BEFORE THE MERIDIAN CITY COUNCIL

CASE NO. FP-2025-0019; A-2025-0113; A-2025-0123
ORDER OF CONDITIONAL APPROVAL OF FINAL PLAT

Final plat consisting of 62 buildable lots and 17 common/other lots on 9.31 acres of land in the R-8 and R-15 zoning districts for the first phase of Pollard North Subdivision.

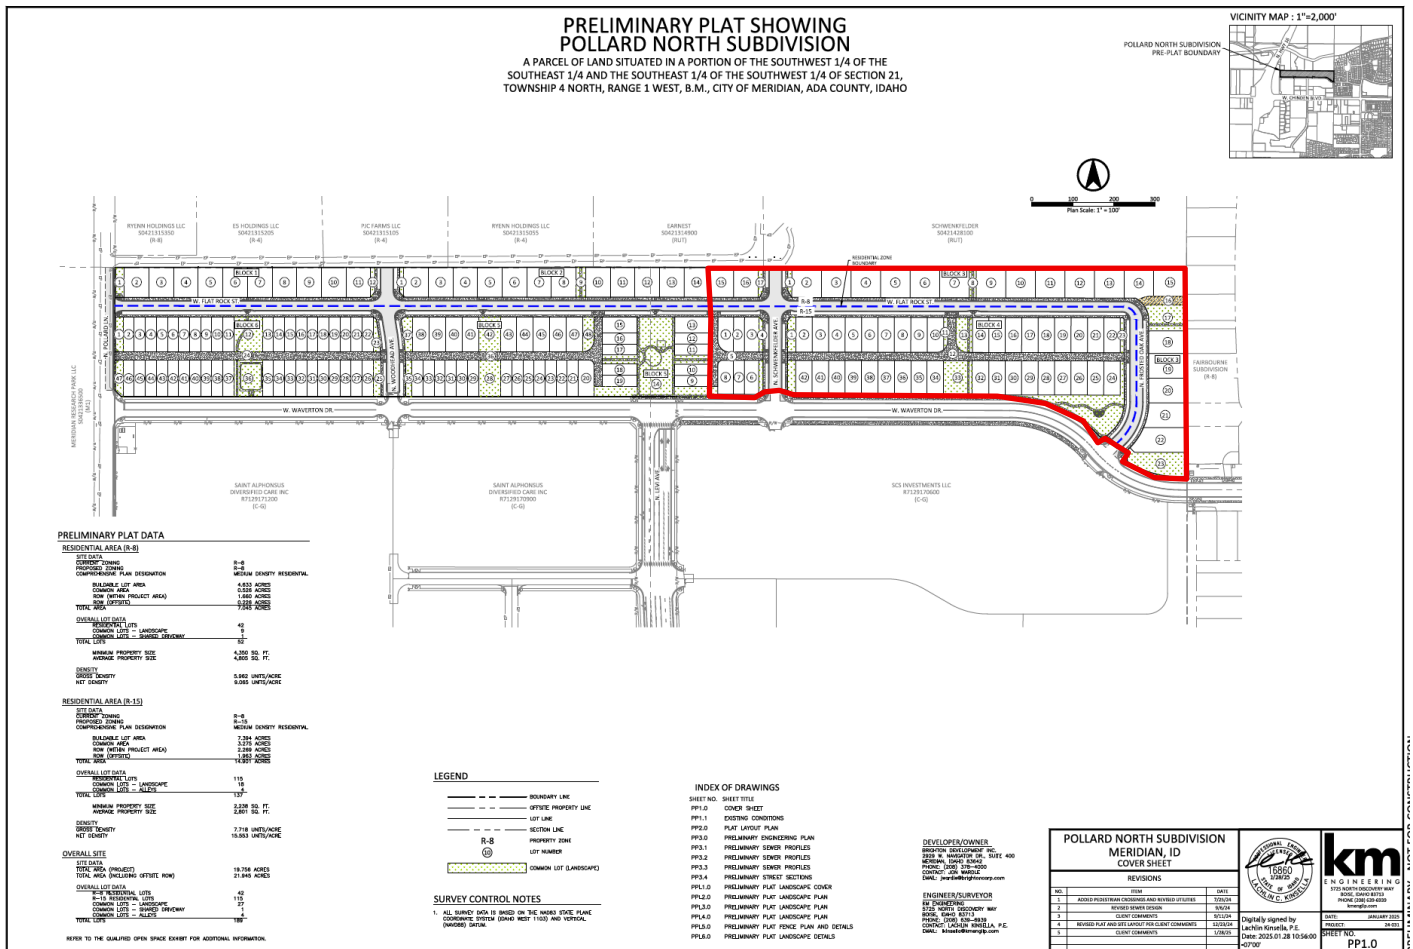
Alternative Compliance is also requested to UDC 11-3B-12C, which requires a minimum 5-foot-wide landscape strip to be provided along each side of all pathways, for the pathway along the northern boundary of Lot 24, Block 2. In this location, the pathway abuts the southern property line of adjacent building lots (i.e. Lots 25-30, Block 2) and a landscape strip is not proposed. The Applicant proposes a landscape strip on adjacent building lots instead of the common area as they feel the pathway creates a clear delineation between the private lots and common area. Landscaped planter beds are provided along adjacent streets on this common lot and additional trees are proposed for shade, while still allowing a large open space for people to gather or recreate in. Staff finds the proposed alternative means of compliance includes innovative design features based on “new urbanism”, which promote connectivity and walkability and meets the findings for such in UDC 11-5B-5E, as noted below in Section V.B.

The Director finds the proposed alternative compliance of providing landscaped planter beds on abutting building lots adjacent to the pathway and along adjacent streets in the common area provides an equal means of meeting requirement.

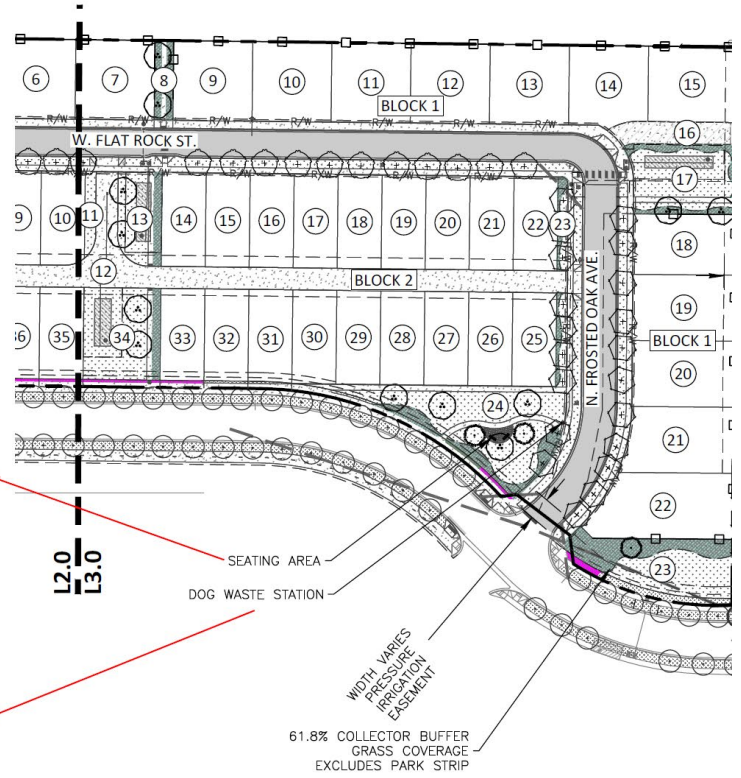
3. Prior to submittal for the City Engineer's signature, have the Certificate of Owners and the accompanying acknowledgement signed and notarized.
4. The final plat prepared by KM Engineering, stamped on 6/11/25 by Aaron L. Ballard, included in Exhibit B shall be revised as follows:

- a. Plat note #4: Include the recorded instrument number of the development agreement (i.e. #2025-029554).
 - b. Plat note #16: Include the recorded instrument number of the ACHD public right-of-way easement (sidewalk).

- c. Plat note #18: Include the recorded instrument number of the ACHD landscape license agreement.
 - d. Include the CP&F No. at the northwest corner on Sheet 1.

- e. Include the recorded instrument number of the Meridian sewer easement graphically depicted on Sheet 2.
 - f. Include the recorded instrument number of the ACHD storm easement graphically depicted on Sheet 2.

- g. Include the recorded instrument number of the Veolia easement graphically depicted on Sheet 2.
5. The landscape plan prepared by KM Engineering, dated August 2025 included in Exhibit C, shall be revised as follows:
